Record of Letter Ballot Review by TC Chapter for Procedural Review

Region/Locale: Japan
 Global Technical Committee: PI&C
 TC Chapter Cochair: Tsuyoshi Nagashima/Miraial, Daisuke Sado/Daihen, Yasuhisa Ito/Murata
 machinery
 Standards Staff: Hirofumi Kanno

Document Number 6688	Document Title New Standard: Specification for 300mm Tape Frame FOUP Load Port
--------------------------------	--

TO: Section/Paragraph Section7 Table 1

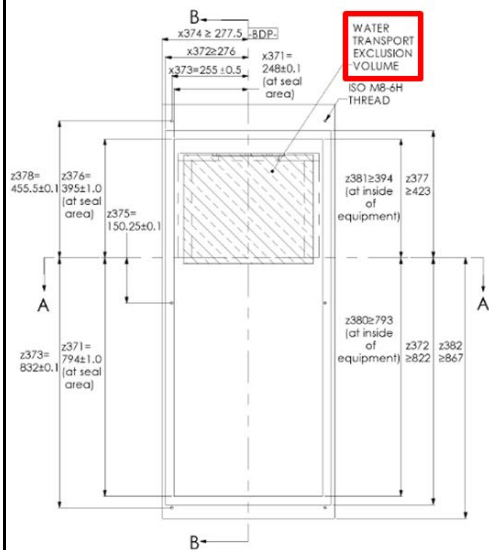
Origin of this editorial change (Check one)			Commenter(s) / Comment(s) #		
			X	Other [Confirmation after voting]		
1	FROM: Section/Paragraph Section7 Table 1					
	x18 °	2 °	143.00 ±0.05 mm °	BDP °	Location of front primary KCP °	
	x19 °	2 °	113.10 ±0.05 mm °	BDP °	Location of front secondary KCP °	
	y15 °	2 °	157.00 ±0.05 mm °	FDP °	Location of rear primary KCP °	
	y16 °	2 °	98.00 ±0.05 mm °	FDP °	Location of Front Primary KCP °	
	y17 °	2 °	77.50 ±0.05 mm °	FDP °	Location of front secondary KCP °	
	y18 °	2 °	121.00 ±0.05 mm °	FDP °	Location of rear secondary KCP °

x18	2	143.00 ±0.05 mm	BDP	Location of front primary KCP
x19	2	113.10 ±0.05 mm	BDP	Location of front secondary KCP
y15	2	157.00 ±0.05 mm	FDP	Location of rear primary KCP
y16	2	98.00 ±0.05 mm	FDP	Location of front ^{secondary} primary KCP
y17	2	77.50 ±0.05 mm	FDP	Location of front secondary KCP
y18	2	121.00 ±0.05 mm	FDP	Location of rear secondary KCP
x18	2	143.00 ±0.05 mm	BDP	Location of front primary KCP
x19	2	113.10 ±0.05 mm	BDP	Location of front secondary KCP
y15	2	157.00 ±0.05 mm	FDP	Location of rear primary KCP
y16	2	98.00 ±0.05 mm	FDP	Location of front ^{secondary} primary KCP
y17	2	77.50 ±0.05 mm	FDP	Location of front secondary KCP
y18	2	121.00 ±0.05 mm	FDP	Location of rear secondary KCP

TO: Section/Paragraph 5.2.10

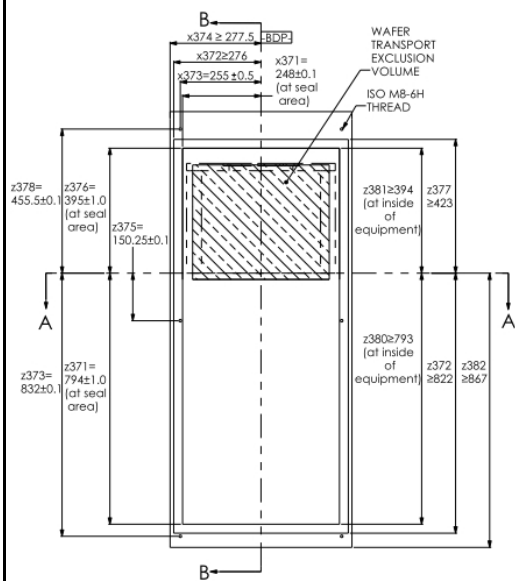
FROM: Section/Paragraph 5.2.10

WATER

WAFER
